Agenda – Executive Policy Committee – October 18, 2017

Item No. 2 Request to Amend Development Agreement Conditions For File DASZ 3/2016 (AG 3/2016) (Transcona Ward)

Title: **REQUEST TO AMEND DEVELOPMENT AGREEMENT CONDITIONS FOR FILE DASZ 3/2016 (AG 3/2016)**

APPENDIX "B" – PROPOSED SCHEDULE G MAP TO AG 3/2016

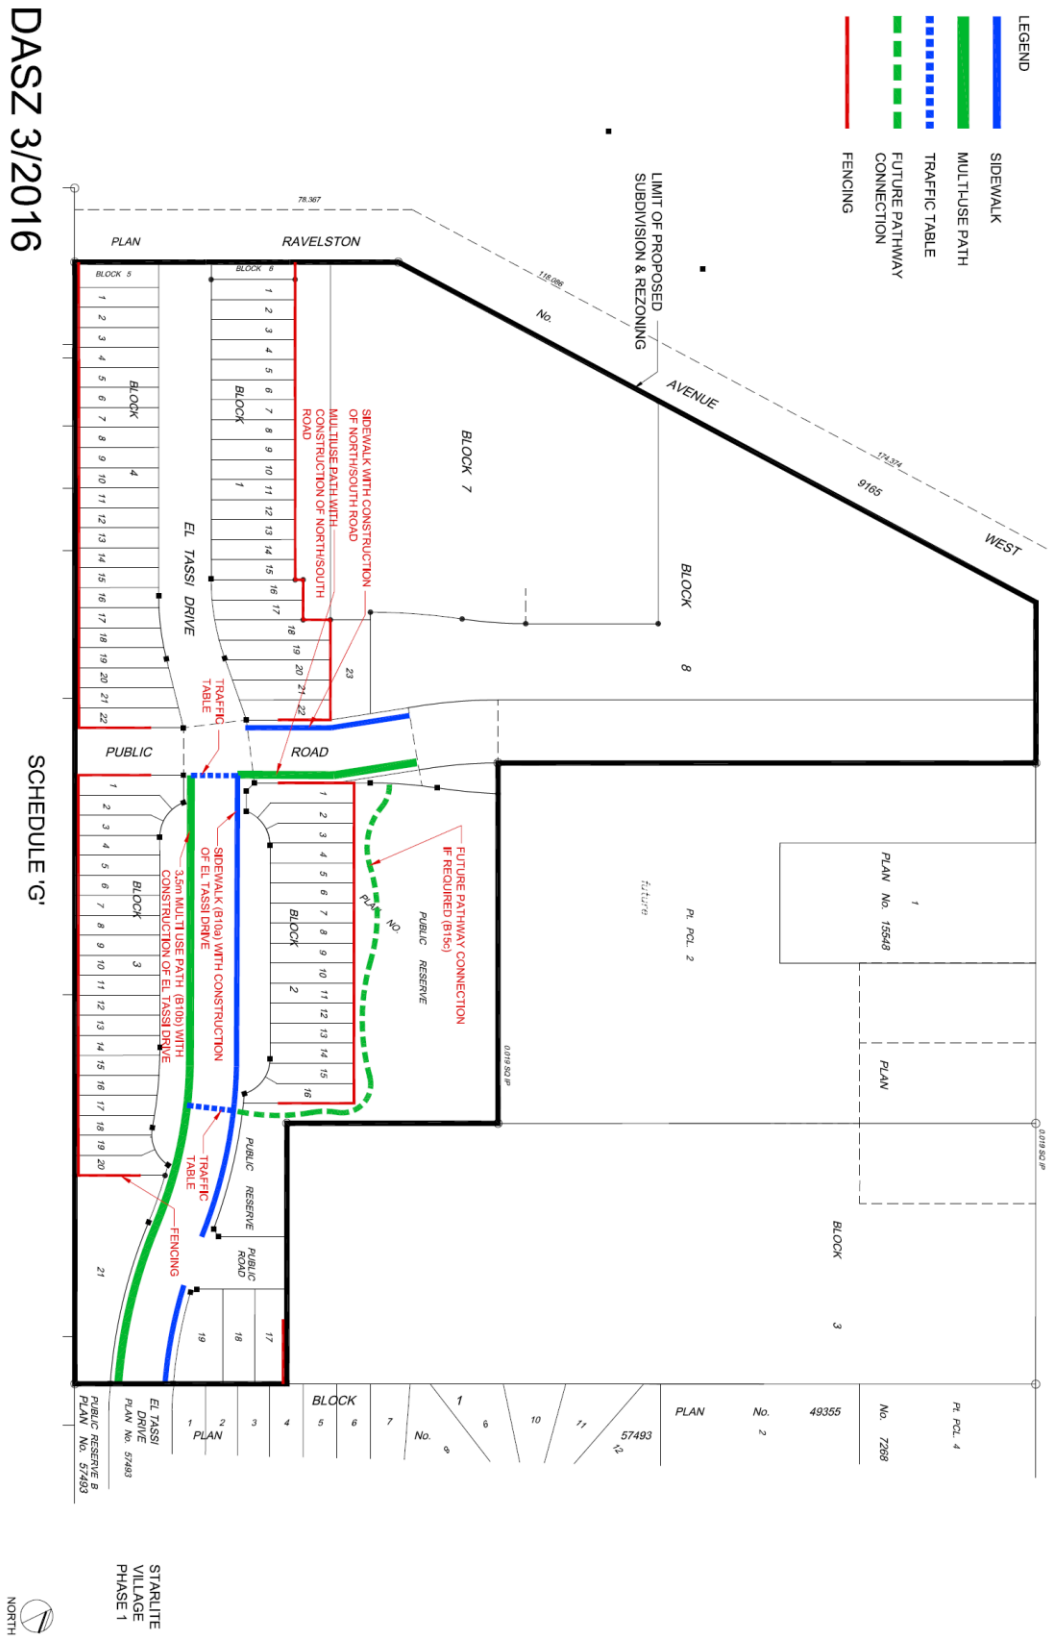
2. That the Developer's request to amend Development Agreement (AG 3/16) to delete and replace the Schedule "G" Map with an amended Schedule "G" listed as Appendix B of this report, be approved, subject to the following:

2. That the Developer's request to amend Development Agreement (AG 3/16) to delete and replace the Schedule "G" Map with an amended Schedule "G" listed as Appendix B of this report, be approved, subject to the following:

Pursuant to Development Agreement AG 3/2016, the Developer is required to, at no expense to the City, construct an east-west multi-use pathway along the proposed extension of El Tassi Drive. The Developer is requesting that this condition be amended so that the pathway would only extend to the future north/south road (identified as “Public Road” in Appendix “B” to this report).

2) **Schedule G**
Delete Schedule 'G' and replace with attached Schedule 'G'.

2. That the Developer’s request to amend Development Agreement (AG 3/16) to delete and replace the Schedule “G” Map with an amended Schedule “G” listed as Appendix B of this report be denied.

APPENDIX C

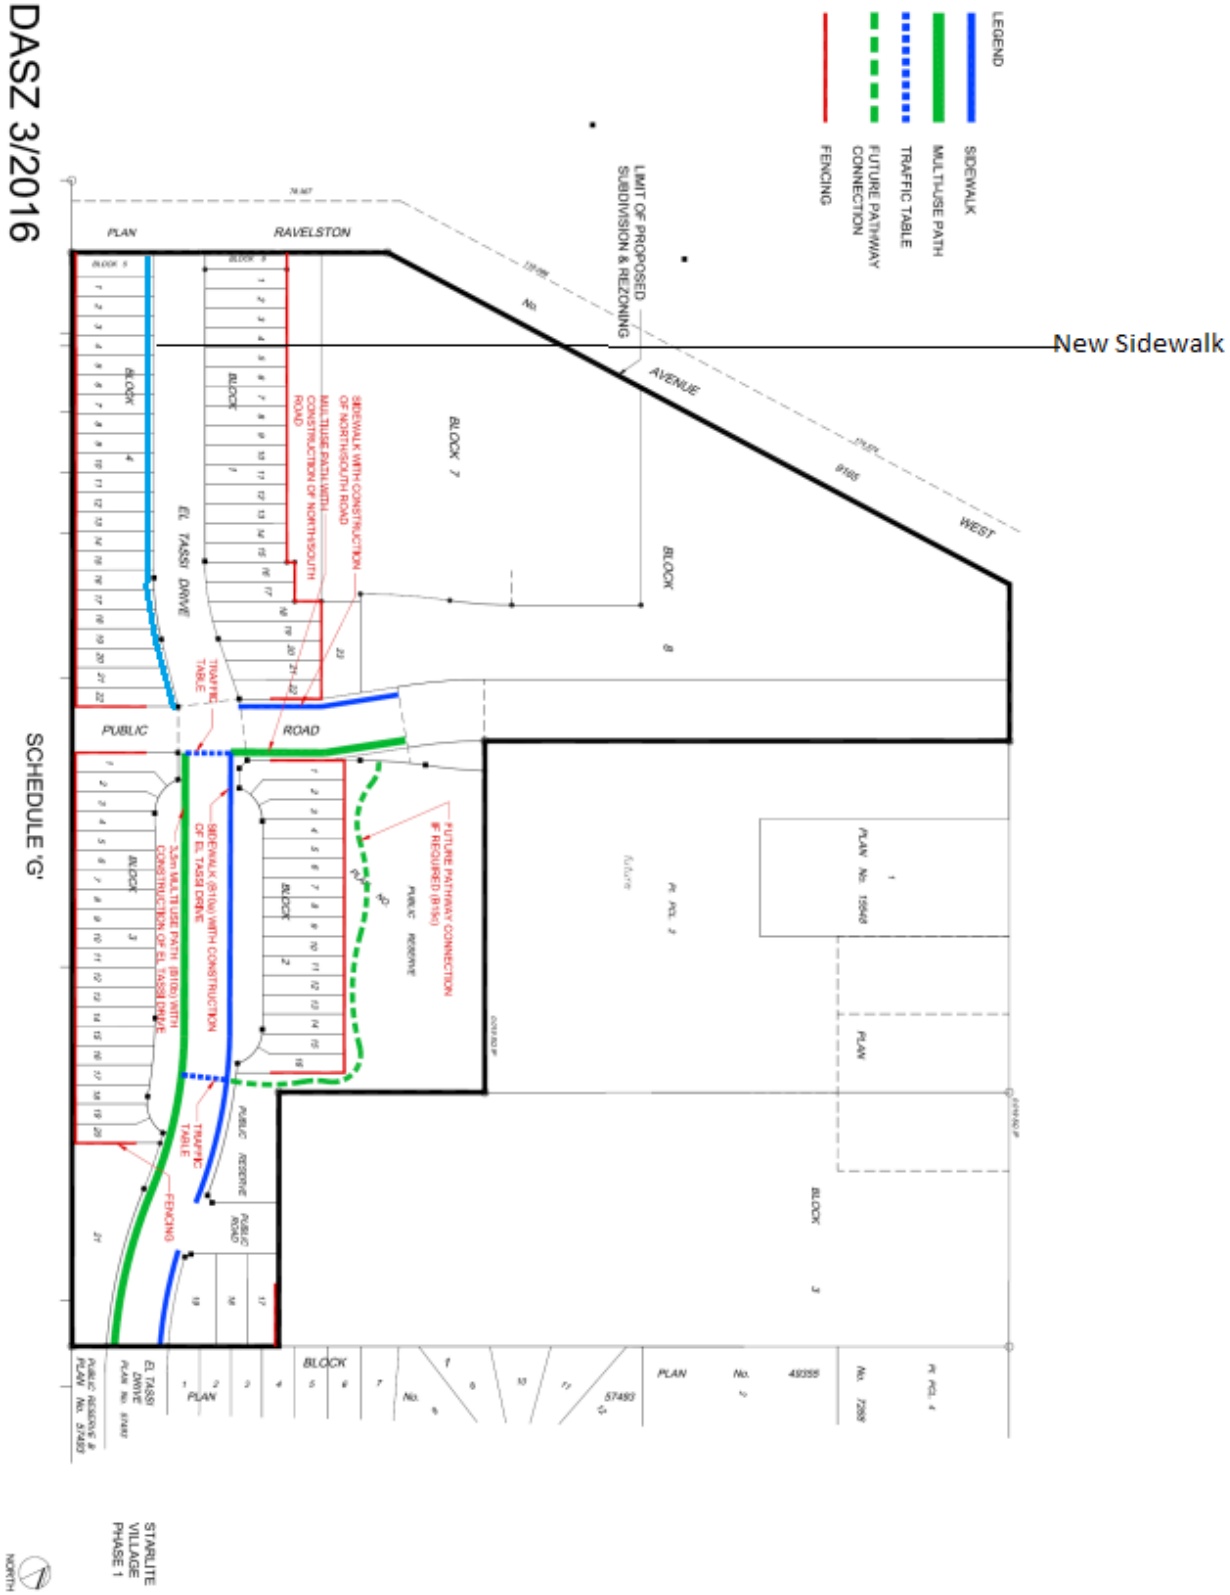
A. That the Developer install a sidewalk on the south side of El Tassi Drive, along Blocks 4 and 5, as outlined in blue on Appendix C.

A. That the Developer install a sidewalk on the south side of El Tassi Drive, along Blocks 4 and 5, as outlined in blue on Appendix C.
